UNITED STATES PATENT AND TRADEMARK OFFICE

APPLICATION NO.	FILING DATE	FIRST NAMED INVENTOR	ATTORNEY DOCKET NO.	CONFIRMATION NO.
10/670,985	09/25/2003	Jaime L. Rugnetta	279.607US1	4509

Office Action Summary	Application No.	Applicant(s)	
	10/670,985	RUGNETTA ET AL.	
	Examiner	Art Unit	
	Nicole R. Kramer	3762

DETAILED ACTION

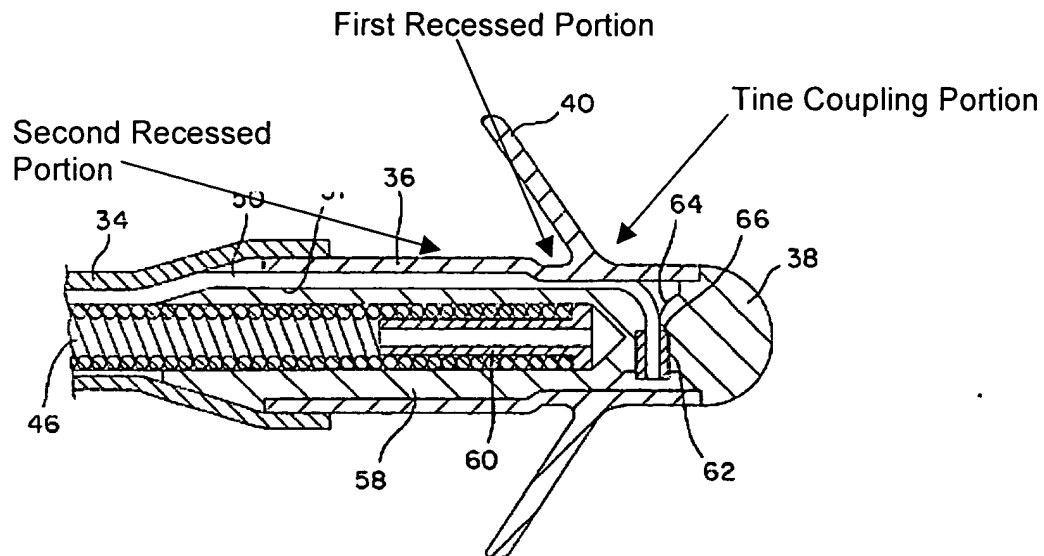
Huepenbecker et al. discloses a lead having at least one tine (40) coupled at the distal end thereof. The tines have a first position extended away from the lead body (as shown in Figure 4 reproduced below). In addition, although not explicitly stated, the tines necessarily have a second collapsed position because the tines are formed of a flexible material such that the tines fold/collapse against the lead body during insertion into the patient. The lead includes two recessed portions, as indicated on Fig. 4 reproduced below. The first recessed portion is longitudinally disposed between the tine coupling portion and the second recessed portion, as shown below. In addition, when the tines collapse during implantation, the first recessed portion would necessarily be recessed away from the bottom surface of the tine.

With respect to claim 4, it appears from Figure 4 that the cross-sectional area at the lead distal end (between electrode 38 and the tine- coupling portion) is approximately the same as the cross-sectional area of the tine coupling portion. Accordingly, the cross-sectional area of the tine coupling area is necessarily "less than 10% smaller" than the cross-sectional area of the lead distal end.

With respect to claim 7, Examiner considers spacer 34 shown on Figure 4 to be an "intermediate portion of the lead body." As shown in Fig. 4, the diameters of the spacer 34, the first recessed portion, and the second recessed portion are each different from one another.

FIG. 5

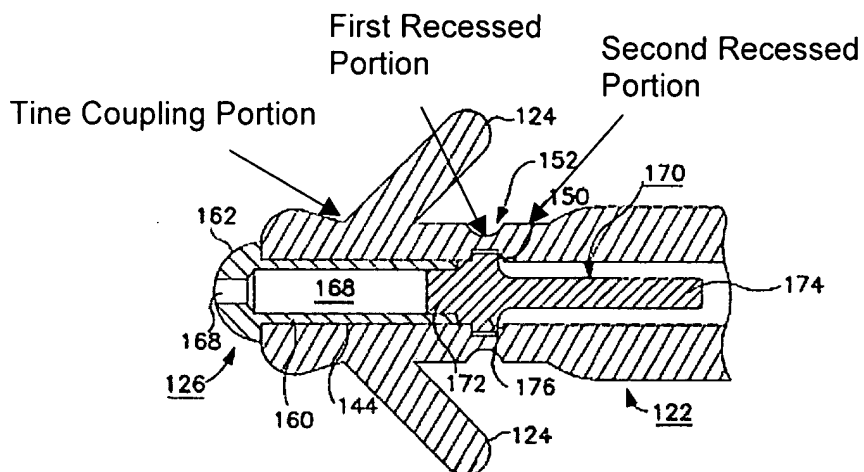
Laske et al. discloses a lead having at least one tine (124) coupled at the distal end thereof. The tines have a first position extended away from the lead body (as shown in Figure 5 reproduced below). In addition, although not explicitly stated, the tines necessarily have a second collapsed position because the tines are formed of a soft, pliant material such that the tines fold/collapse against the lead body during insertion into the patient (see col. 5, lines 23-37). The lead includes two recessed portions, as indicated on Fig. 5 reproduced below. The first recessed portion is longitudinally disposed between the tine coupling portion and the second recessed portion, as shown below. In addition, when the tines collapse during implantation, the

With respect to claim 4, it appears from Figure 5 that the cross-sectional area at the lead distal end is slightly larger than the cross-sectional area of the tine coupling portion. Examiner considers the cross-sectional area of the tine coupling area to be approximately "less than 10% smaller" than the cross-sectional area of the lead distal end.

With respect to claim 7, Examiner considers tubular sheath 122 shown on Figure 5 to be an "intermediate portion of the lead body." As shown in Fig. 5, the diameters of the sheath 122, the first recessed portion, and the second recessed portion are each different from one another.
